Notice of Intent

Type of Action: Variance

Procedure Description: Devon Energy Production Co., L.P. (Devon) respectfully requests a variance to break test.

PECOS DISTRICT DRILLING CONDITIONS OF APPROVAL

Section 2 - Blowout Preventer Testing Procedure

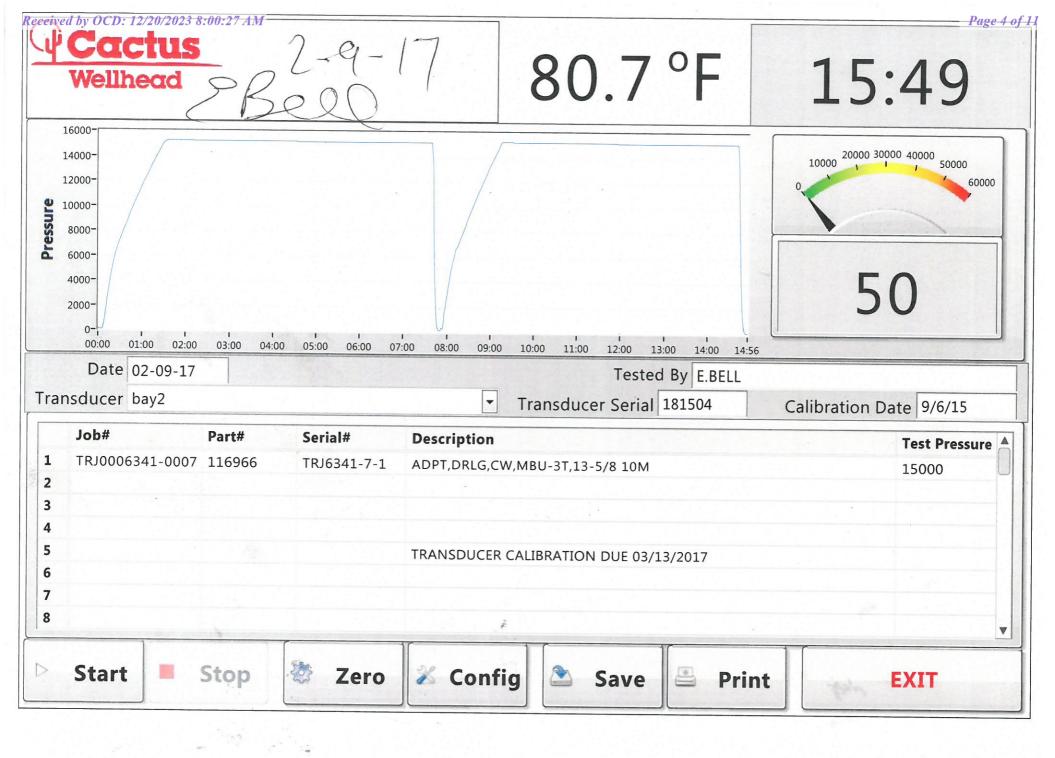
Devon Energy requests to only test BOP connection breaks after drilling out of surface casing and while skidding between wells which conforms to API Standard 53 and industry standards. This test will include the Top Pipe Rams, HCR, Kill Line Check Valve, QDC (quick disconnect to wellhead) and Shell of the 10M BOPE to 5M for 10 minutes. If a break to the flex hose that runs to the choke manifold is required due to repositioning from a skid, the HCR will remain open during the shell test to include that additional break. The variance only pertains to intermediate hole-sections and no deeper than the Bone Springs Formation where 5M BOP tests are required. The initial BOP test will follow OOGO2.III.A.2.i, and subsequent tests following a skid will only test connections that are broken. The annular preventer will be tested to 100% working pressure. This variance will meet or exceed OOGO2.III.A.2.i per the following: Devon Energy will perform a full BOP test per OOGO2.III.A.2.i before drilling out of the intermediate casing string(s) and starting the production hole, before starting any hole section that requires a 10M test, before the expiration of the allotted 14-days for 5M intermediate batch drilling or when the drilling rig is fully mobilized to a new well pad, whichever is sooner. We will utilize a 200' TVD tolerance between intermediate shoes as the cutoff for a full BOP test. The BLM will be contacted 4hrs prior to a BOPE test. The BLM will be notified if and when a well control event is encountered. Break test will be a 14 day interval and not a 30 day full BOPE test interval. If in the event break testing is not utilized, then a full BOPE test would be conducted.

- 1. Well Control Response:
- 1. Primary barrier remains fluid
- 2. In the event of an influx due to being underbalanced and after a realized gain or flow, the order of closing BOPE is as follows:
 - a) Annular first
 - b) If annular were to not hold, Upper pipe rams second (which were tested on the skid BOP test)
 - c) If the Upper Pipe Rams were to not hold, Lower Pipe Rams would be third

All Previous COAs Still Apply. Variance request procedure is approved as written, please see below general conditions for variance.

- BOPE Break Testing is ONLY permitted for 5M BOPE or less. (Annular preventer must be tested to a minimum of 70% of BOPE working pressure and shall be higher than the MASP)

- BOPE Break Testing is NOT permitted to drilling the production hole section.
- Variance only pertains to the intermediate hole-sections and no deeper than the Bone Springs formation.
